Modification Application to DA 10.2014.743.3

Submitted under Section 4.55(1)(a) of the EP&A Act, 1979

Approved staged residential development at No.2 Kulgun Court, Ocean
Shores

March 2021

Fig 3. Proposed staging diagram (refer also to full set in the attached **separate annexures**).

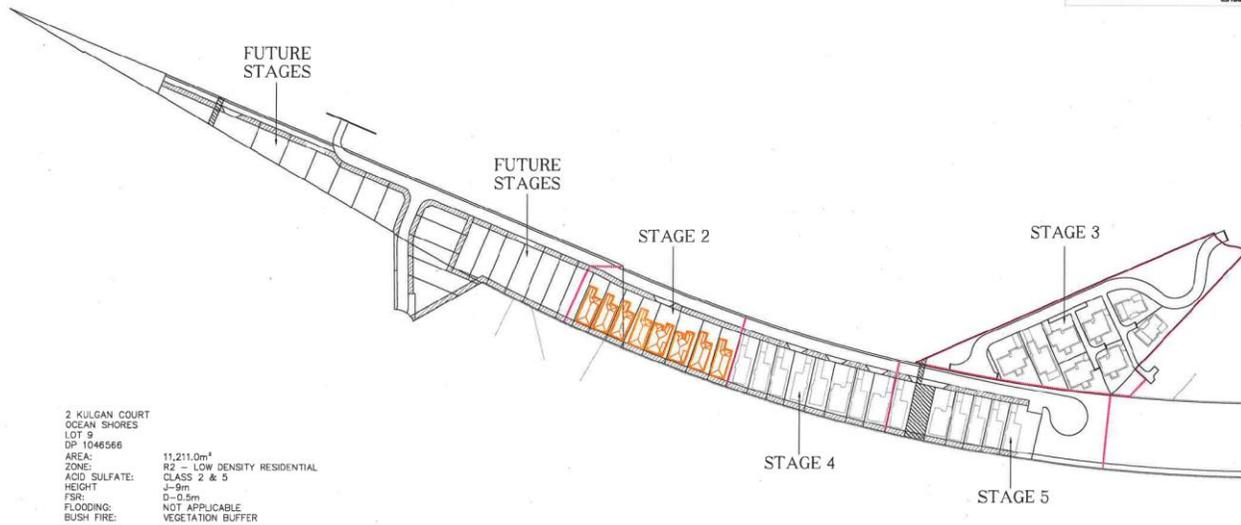
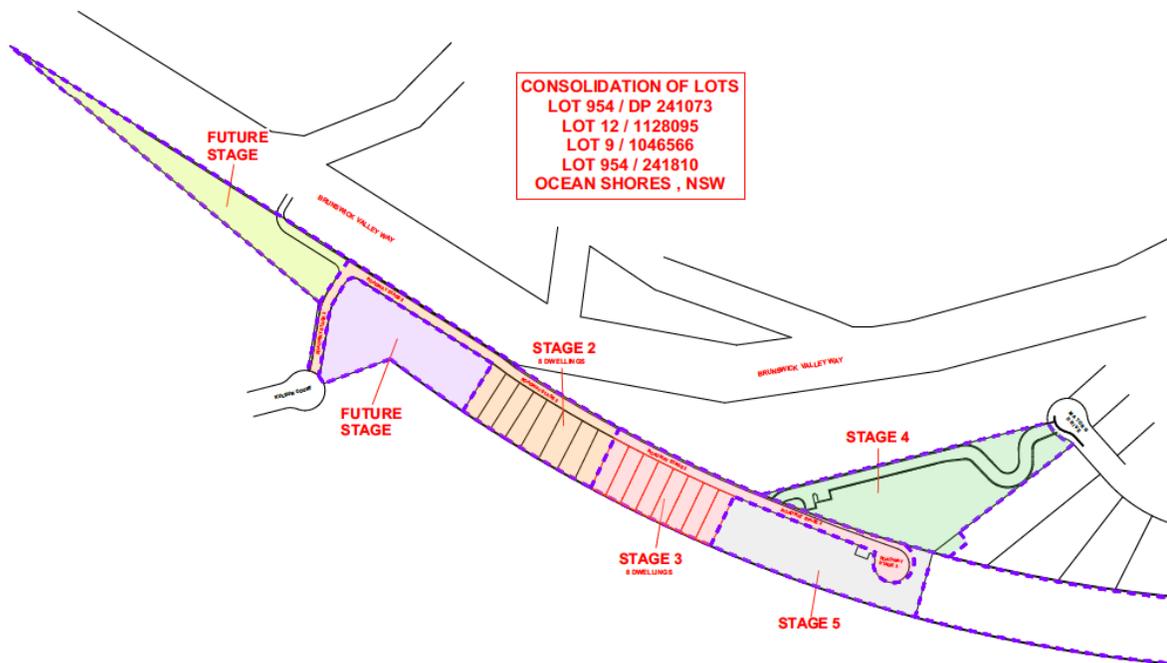
MODIFICATION No.1 – Modification of the Proposal Description as it relates to staging:-

Delete the following existing description of staging:

And replace it with the following staging description: -

Stage 1 - Torrens Title Lot Consolidation of 3 Lots to 1 Lot and Boundary Adjustment (between two existing Lots). Complete.

Stage 2 - Works located on Proposed Lot 1. Construction of eight (8) dwellings, driveway, car parking and access to Kulgún Court, and Strata Subdivision; Complete

Stage 3 – Eight Dwellings and extension of internal road works as shown. Associated strata subdivision and driveway, car parking, and access works to the lot fronting Matong Drive (stage 4) inc. a locked gate for Emergency Services (gate to be locked to prevent access through the site to Kulgún Court/Brunswick Valley Way), Services and Easements as required;

Stage 4 - Works located on land fronting Matong Drive, dwelling construction and access, services, easements and strata registration as required;

Stage 5 – Site works and construction of six (6) dwellings, services, driveway, carparking, easements and Strata Subdivision.

Stage 6 (future stage) – to be confirmed, otherwise as per existing approvals

Stage 7 (future stage) – to be confirmed, otherwise as per existing approvals

Fig 6. Proposed elevational and external treatments (typically) (refer also to full set in the attached **separate annexures**).

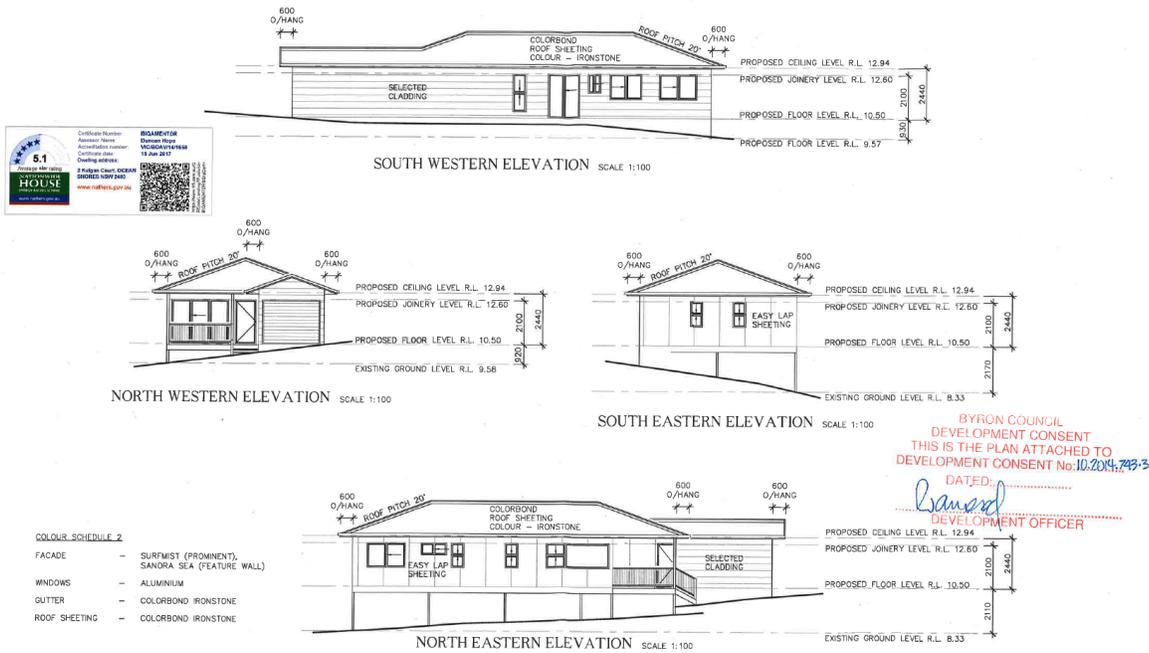
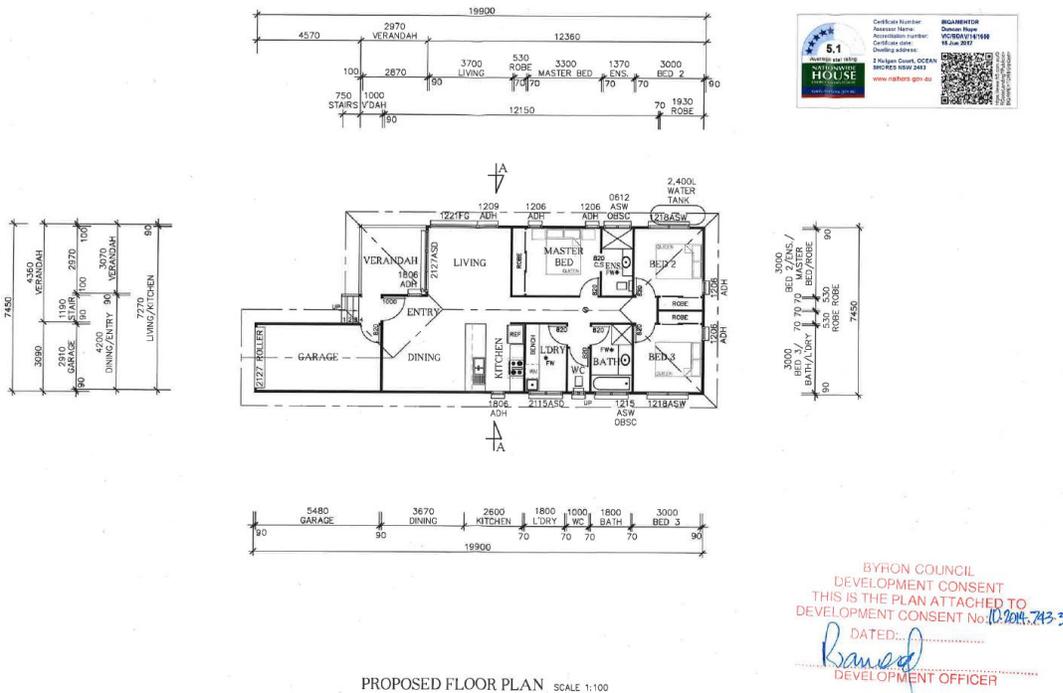
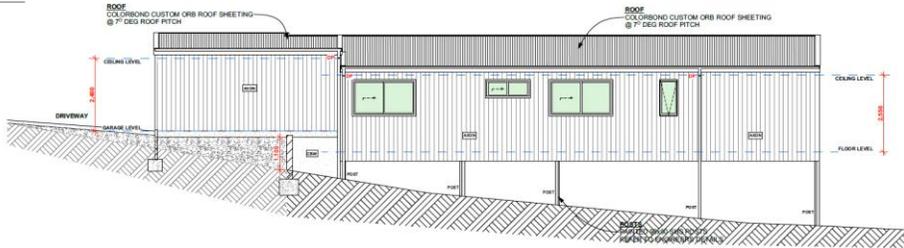
The proposed modification seeks to introduce a more streamlined modern and climatically responsive design orientation for the eight dwellings within stage 3 (as proposed).

- a. Retention of footprints and setbacks as approved;
- b. Replacement of traditional roof forms and façade treatments with a modern contemporary form; and
- c. Integration of additional site topography data and therefore the amended plans show a more accurate representation of existing levels and proposed sub structure treatments.
